MILITARY SPECIFICATION

MICROCIRCUITS, LINEAR, HIGH SLEW RATE OPERATIONAL AMPLIFIERS,
MONOLITHIC SILICON

This amendment forms a part of MIL-M-38510/122A, dated 15 September 1989, and is approved for use by all Departments and Agencies of the Department of Defense.

" Device types 07 and 08

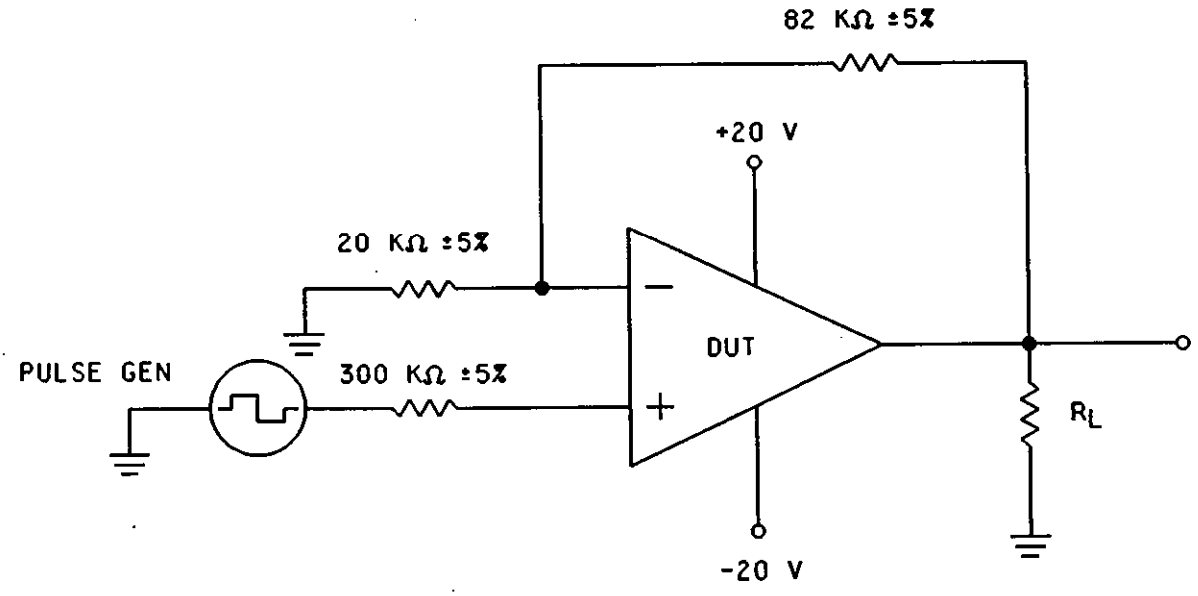
FIGURE 5, add the following figure:

FIGURE 5, NOTE 1b, delete and substitute the following:

FIGURE 5, NOTE 3, add the following sentence:

"b. ±V = 5.0 V for device types 01 through 06 and ±V = 1.0 V for device types 07 and 08."

"R_L = 2 kΩ ±5% for device types 07 and 08."

FIGURE 7. Settling time circuits. "

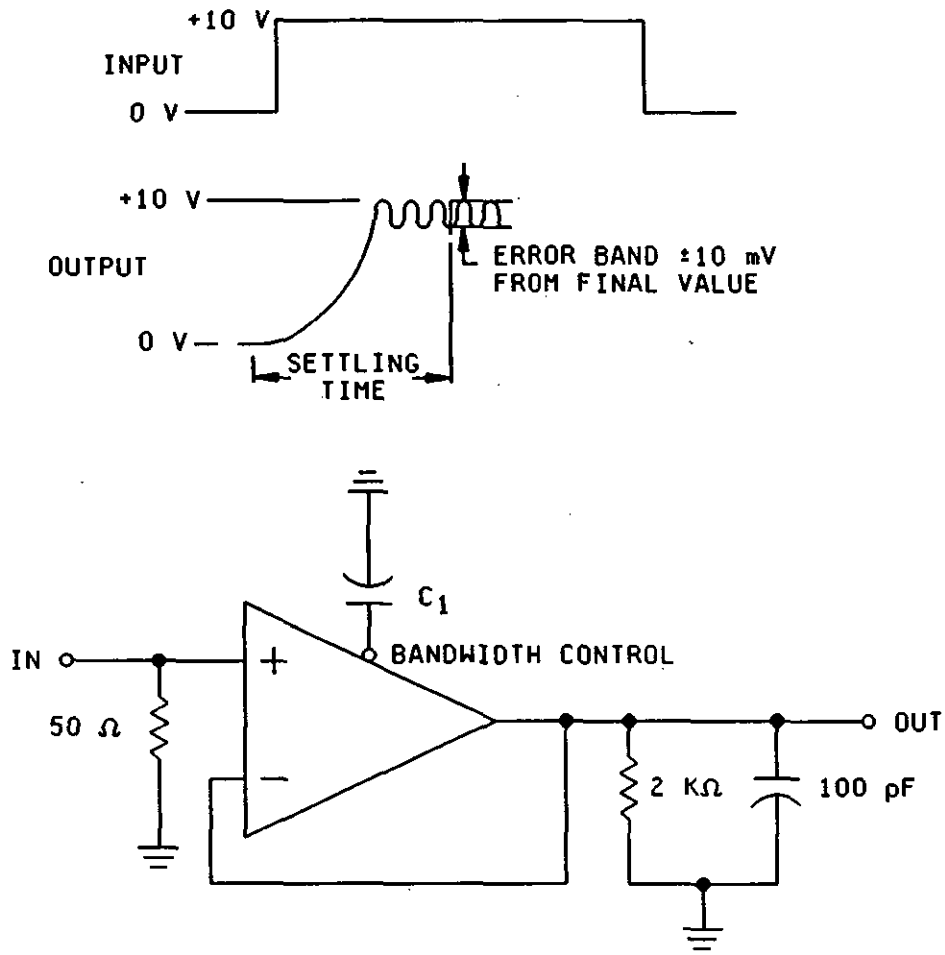
FIGURE 7, delete and substitute the following:

" Device type 02

NOTE: C1 is test fixture capacitance and shall be 1.5 pF ±1.0 pF.

FIGURE 7. Settling time circuits - Continued. "

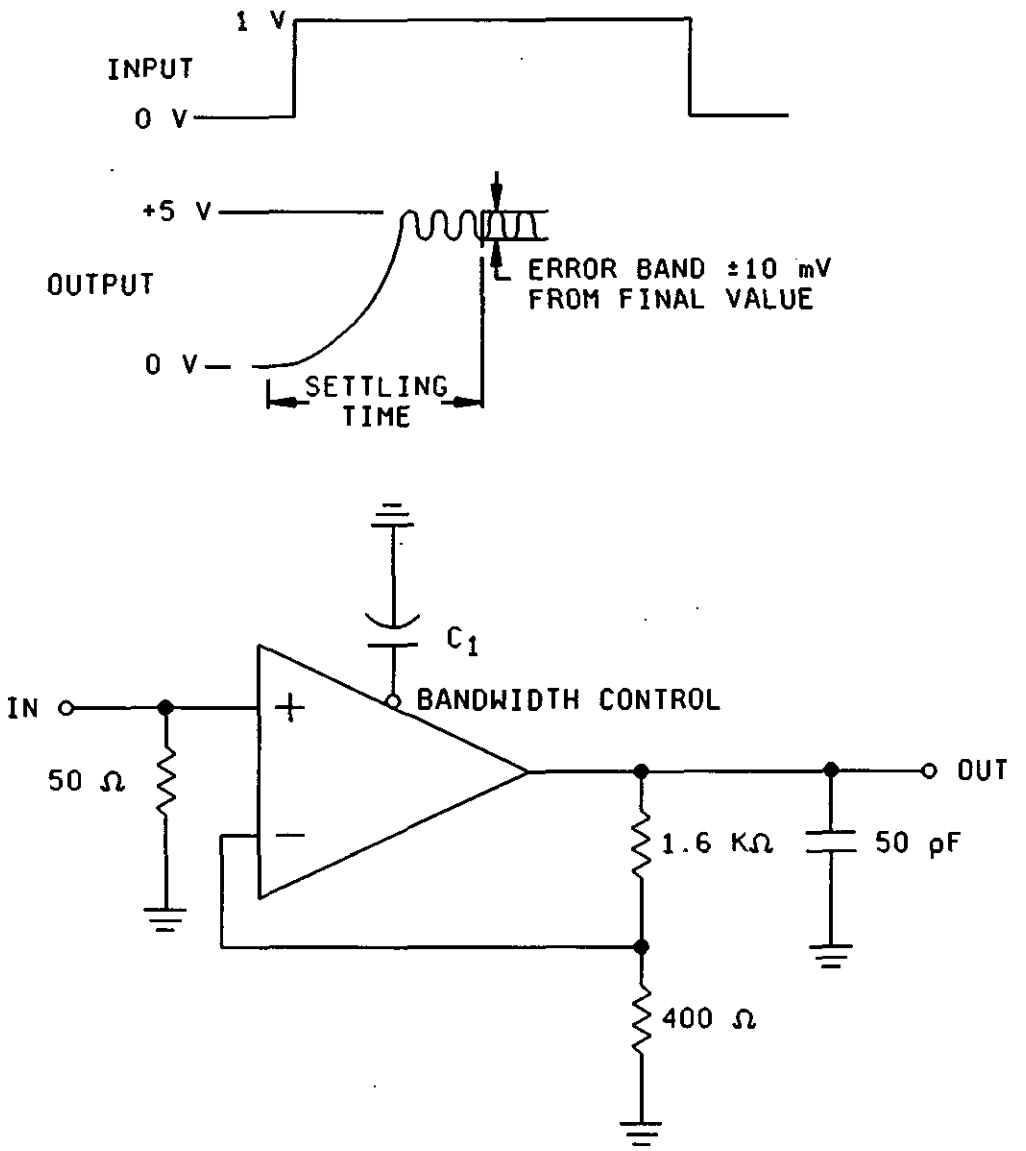
FIGURE 7, delete and substitute the following:

" Device type 03

NOTE: C1 is test fixture capacitance and shall be less than 1.0 pF.

FIGURE 7. Settling time circuits - Continued. "

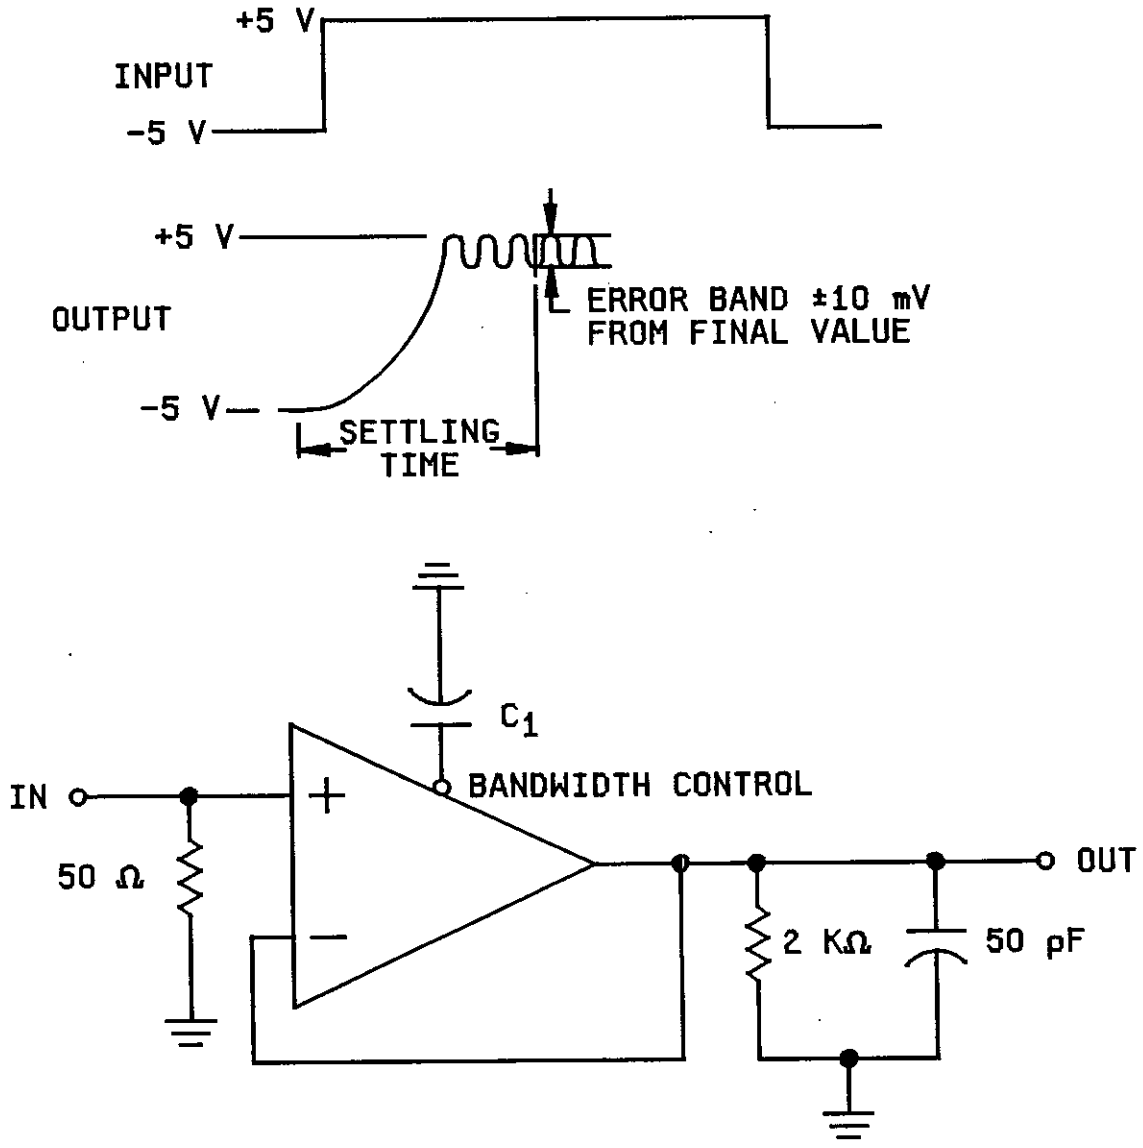
FIGURE 7, delete and substitute the following:

" Device types 04 and 05

NOTE: C1 is test fixture capacitance and shall be less than 1.0 pF.

FIGURE 7. Settling time circuits - Continued. "

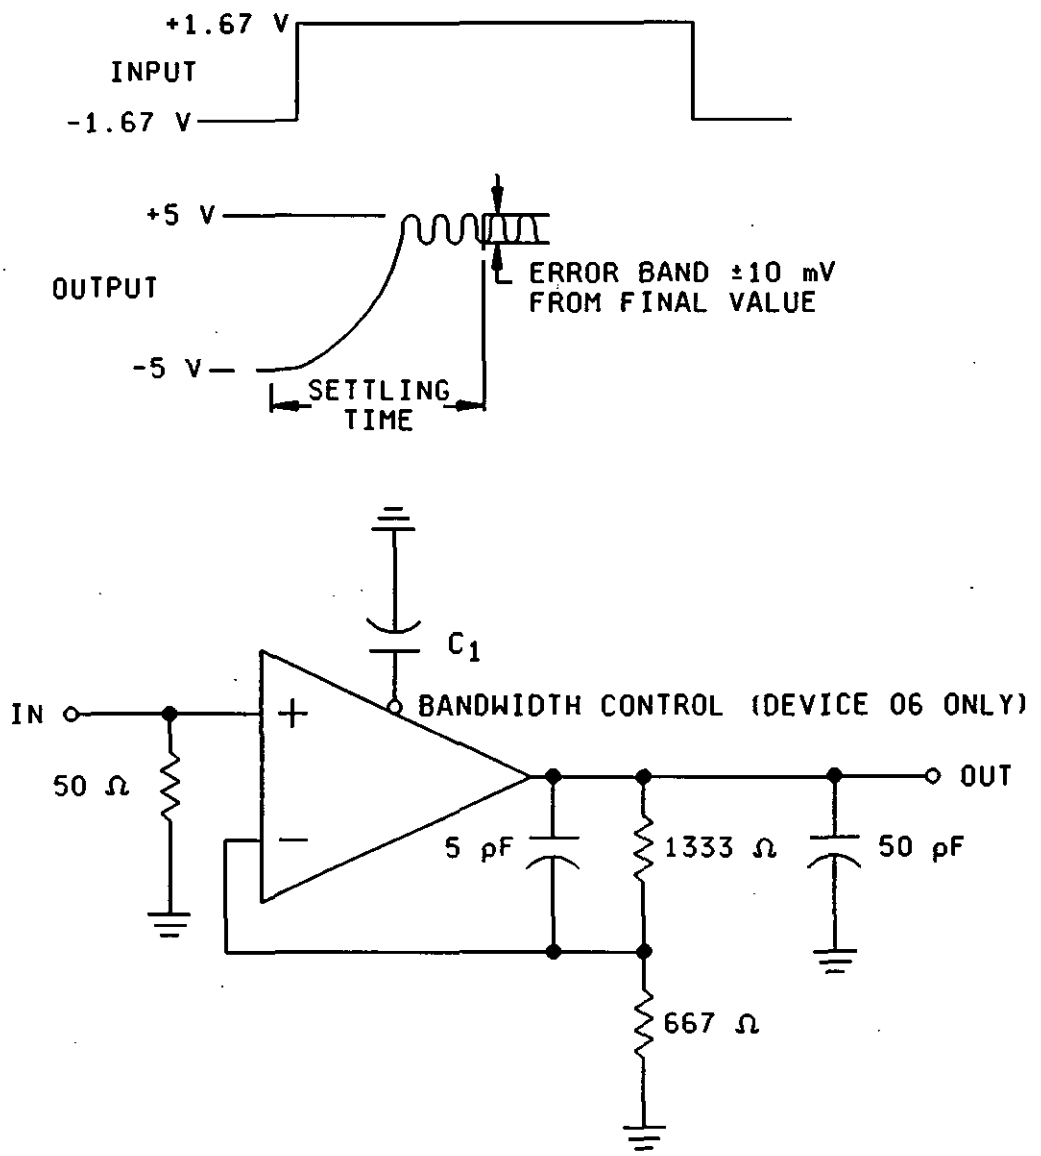
FIGURE 7, delete and substitute the following:

" Device types 06 and 07

NOTE: C1 is test fixture capacitance and shall be 2.5 pF ±1.0 pF.
